From: Michael Lavender
Sent: 09 April 2015 13:03
To: Matthew Porter
Subject: FW: 378-380 Brighton Road, Shoreham.
Attachments: Letter Report v2 - 50dB Separating Floor - 378-380 Brighton Road.pdf

Site: 378 – 380 Brighton Road, Shoreham by Sea, BN43
Requirement: Specification of a separating floor construction to achieve DnTw + Ctr 50dB

Figure 1: Separating Floor Make-Up

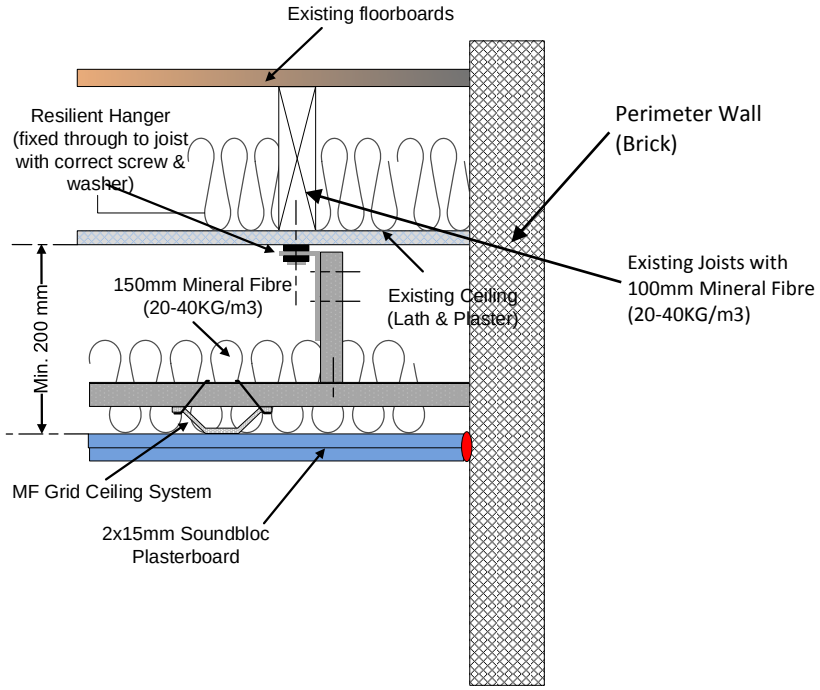
as discussed, there are two fire places shown on the plan. Stephen Bromley may be able to advise further as to whether these go upstairs but if they do any scheme may need to include controlling flanking noise from these areas.

It is recommended that the use of a Suspended Metal Furring (MF) Grid system is installed to the underside of the existing ceiling, leaving the existing ceiling in-tact (made good if damaged). The Grid should create 200mm void and incorporate 150mm thickness of dense mineral fibre such as Rockwool Rw45 or British Gypsum Isover APR1200. Resilient Hangers should be used for attaching the MF Grid to the existing joists/ceiling. The new ceiling should incorporate 2x 15mm Soundbloc. Each plasterboard layer should be taped and sealed, staggering the joints of the two layers. Each layer should also be left short of the perimeter by 3 – 5mm and sealed with a non-hardening mastic.

100mm Mineral Fibre should also be placed between the joists. 6mm Hardboard should also be placed over the existing joists.
Recessed lighting should **not** be installed to the ceiling as this would significantly reduce the effectiveness of the separating construction. If recessed lighting is wished for, then an alternative design would need to be investigated.

The figure below shows separating construction described above. It also shows the use of wall linings to the perimeter walls if required:

The use of 2x 15mm Soundbloc would achieve a 60 minute fire resistance (though this should be confirmed by a fire officer).

It is noted that there are fire places within the perimeter walls. These should be blocked up where possible and lined with a wall lining system in the using one of the methods described in the above section.

Figure 2: Pelmet Detail

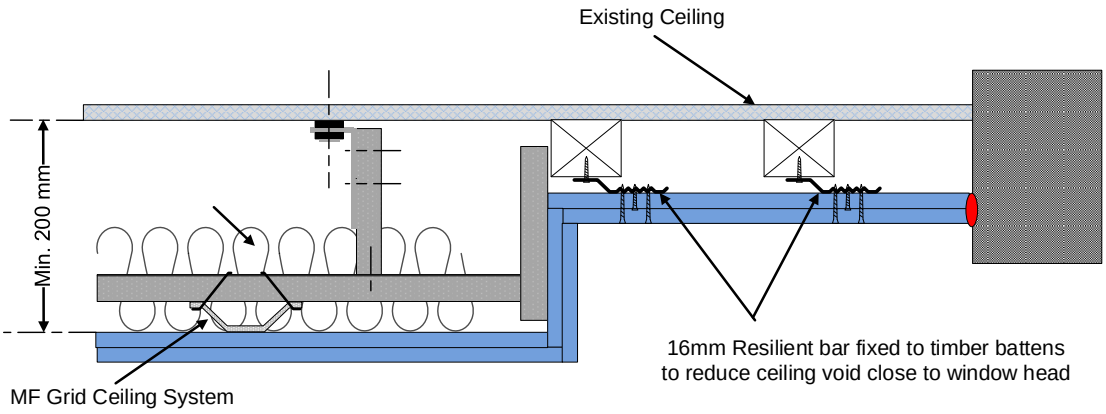
It is noted that currently on the ground floor, the windows are shop windows which run full height of the storey. Where the suspended ceiling meets the window, a pelmet should be formed to keep the acoustic separation in place.

If required, the pelmet can also be angled, by shaping the timber battens accordingly, to which the resilient bar should then be fit.

N.B. It is imperative that the correct length screws are used with resilient bar as any breach in this will severely undermine the performance of the floor.
